Re: FINAL APPROVAL OF PETITION FROM KRIST OIL – REQUESTING PLANNED DEVELOPMENT DISTRICT ON PARCEL AL-56-2, LOCATED AT 1921 RIVERSIDE DRIVE

Date: 12 October 2015

Staff Comments for Final Approval of Krist Oil PDD on Parcel AL-56-2, 1921 Riverside Drive

REVIEW COMMENTS ON KRIST FOOD MART NO. 1 PLANS

PROPOSED LANDSCAPING PLAN

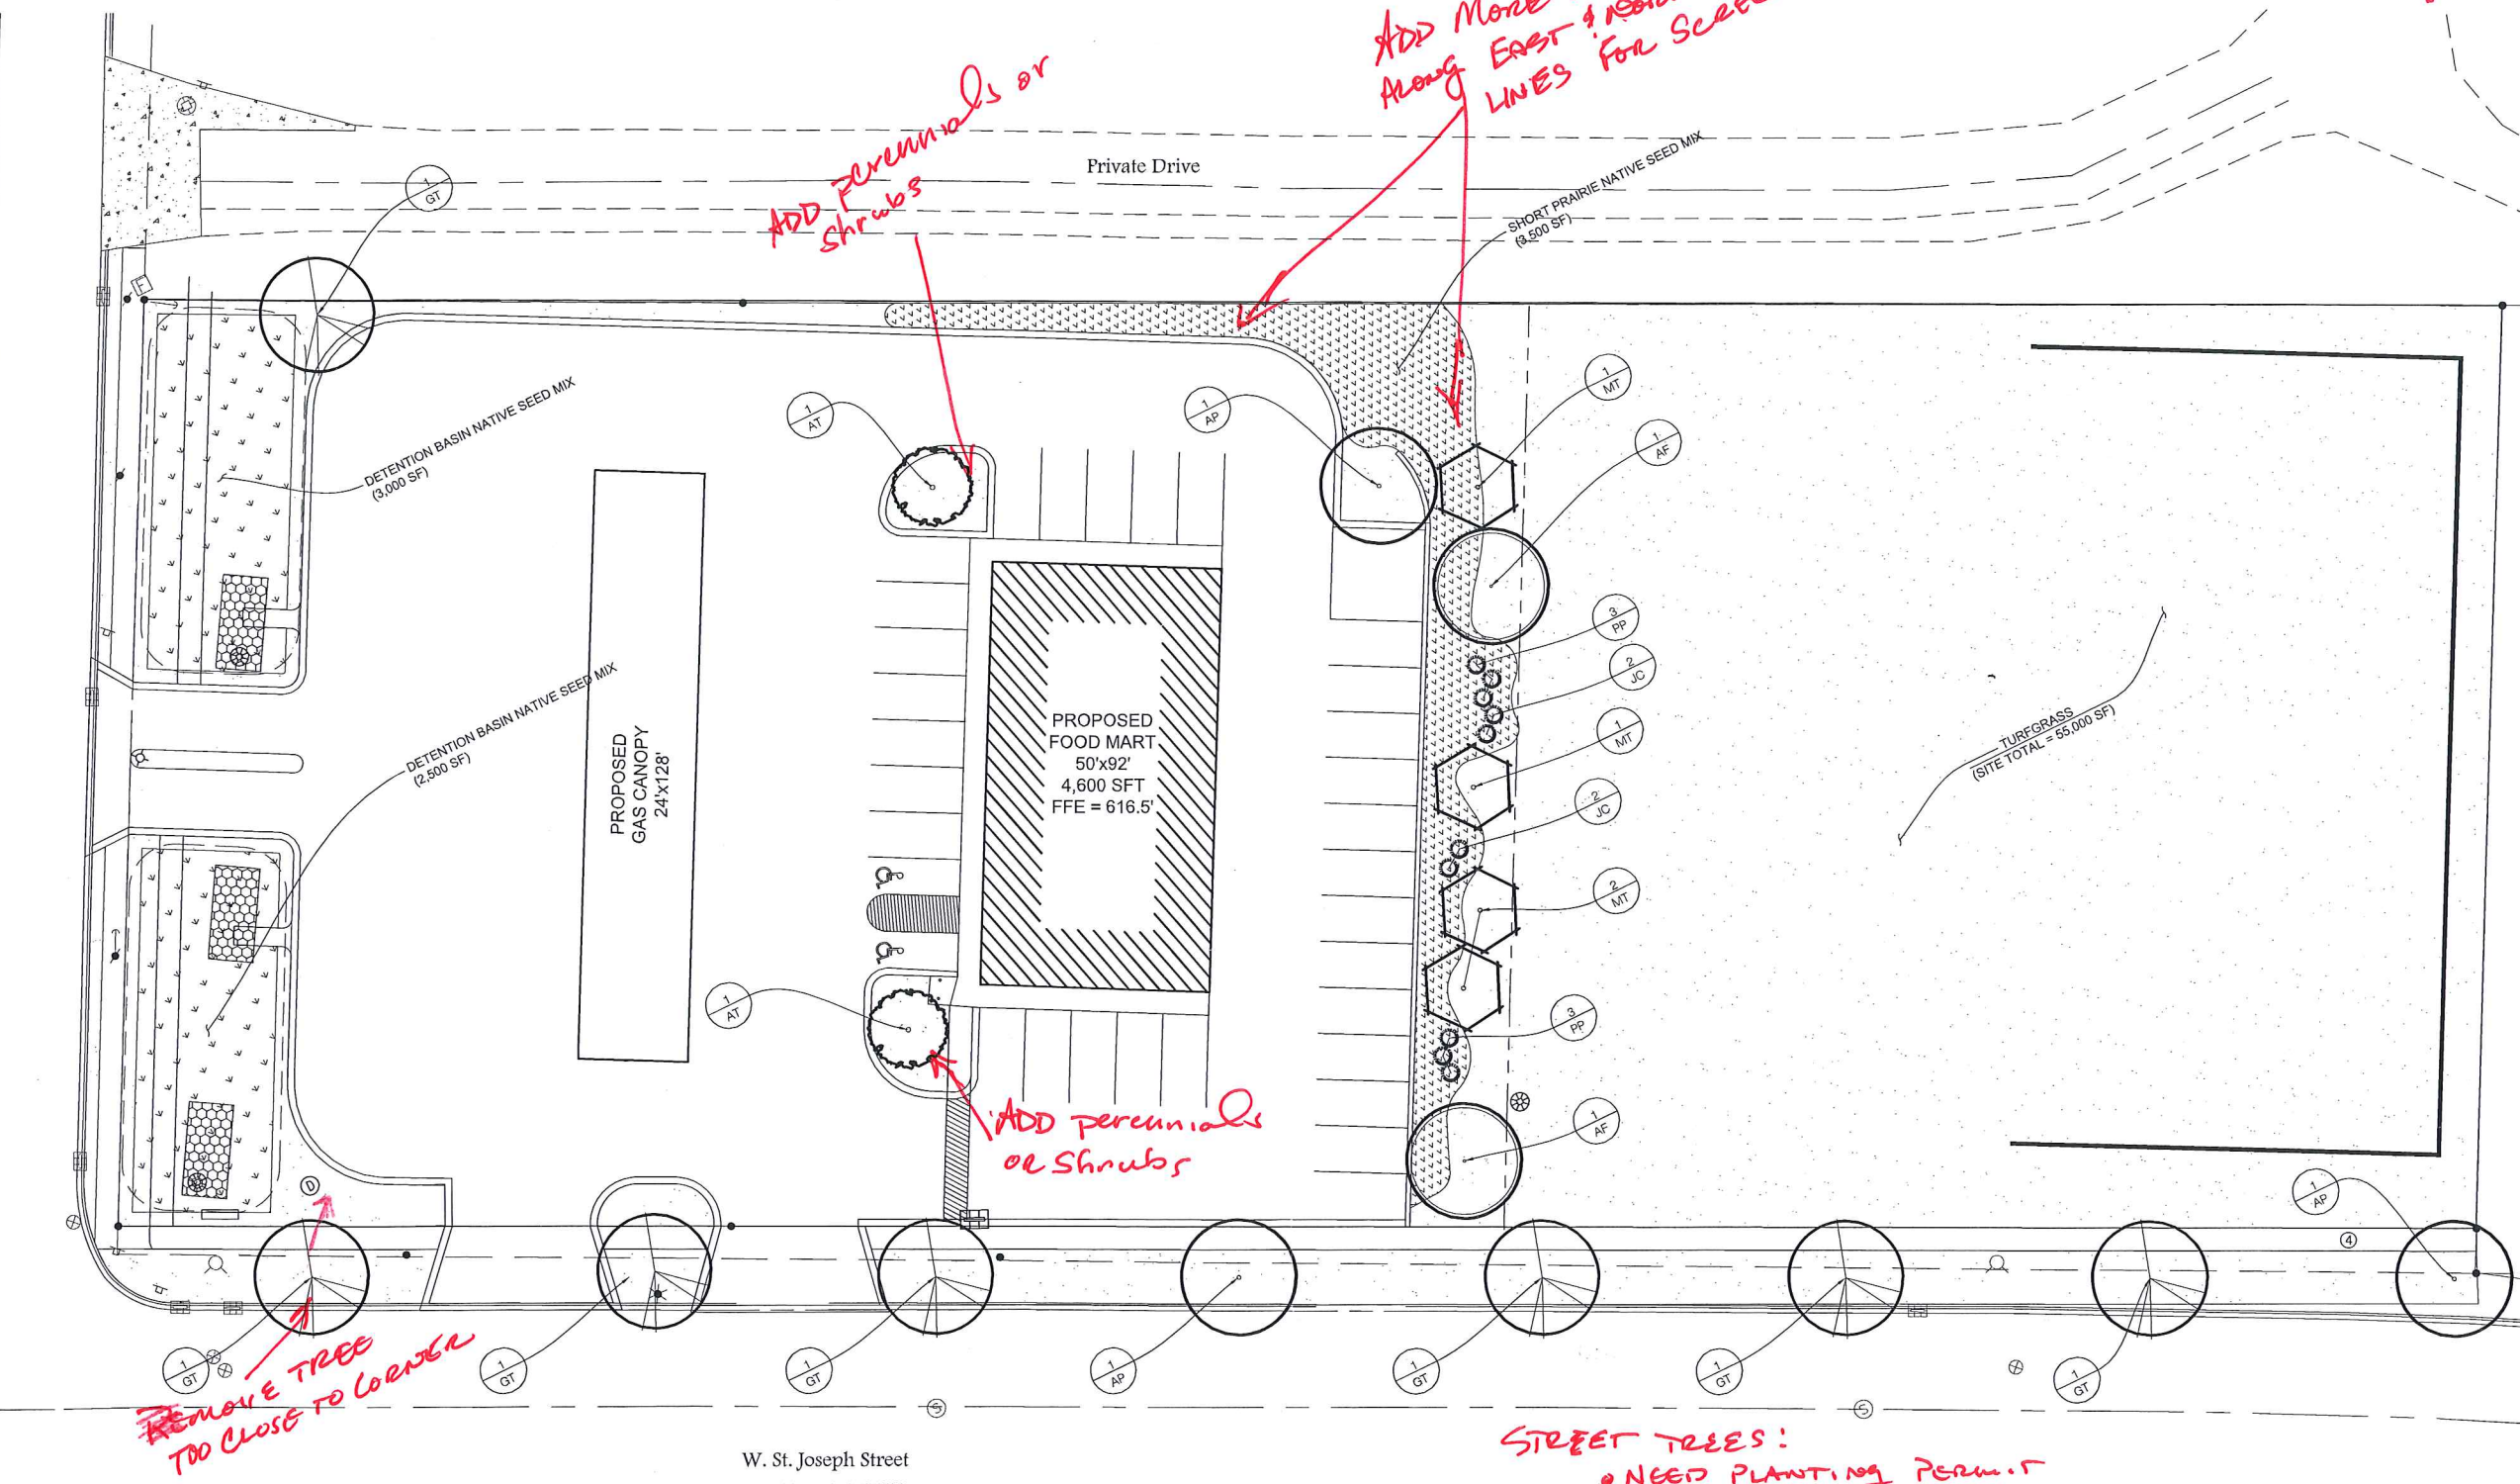
Forestry Department:

- See attached landscaping plan for reference
- Relocate proposed tree at southwest corner to other side of sidewalk
- Add perennials or shrubs to plant beds in front of store
- Add more shrubbery along NE property for additional screening
- Street trees – require planting permit, plant per village specifications, plant after reconstruction of W St. Joseph Street or escrow funds for village to plant street trees after project (2017)
- Forego street trees in front of east lot until development occurs
- Autumn Blaze Maple species get large and can block view
